PREVOST

**SAFETY
RECALL**

SR22-05C

DATE :	September 2022	SECTION :	06 ELECTRICAL
SUBJECT:	ALTERNATOR BELTS REPLACEMENT

BOSCH HD10

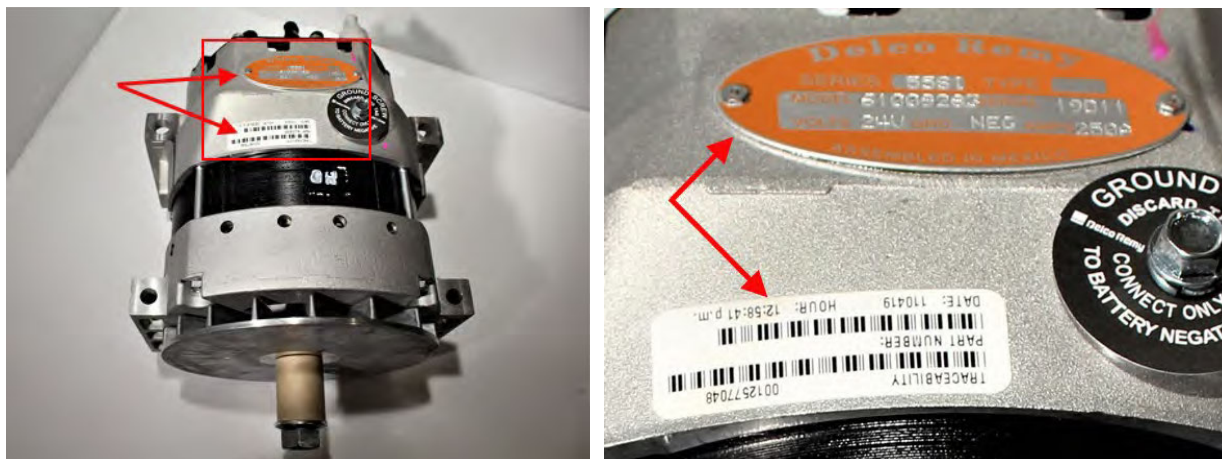
- BOSCH HD10 OEM alternator will have a Prevest part number stamped on the back cover (as well as Bosch part numbers).

- These identification marks (numbers) can either be printed in white or stamped/molded in the plastic cover (150amp HD10 with white marking shown).
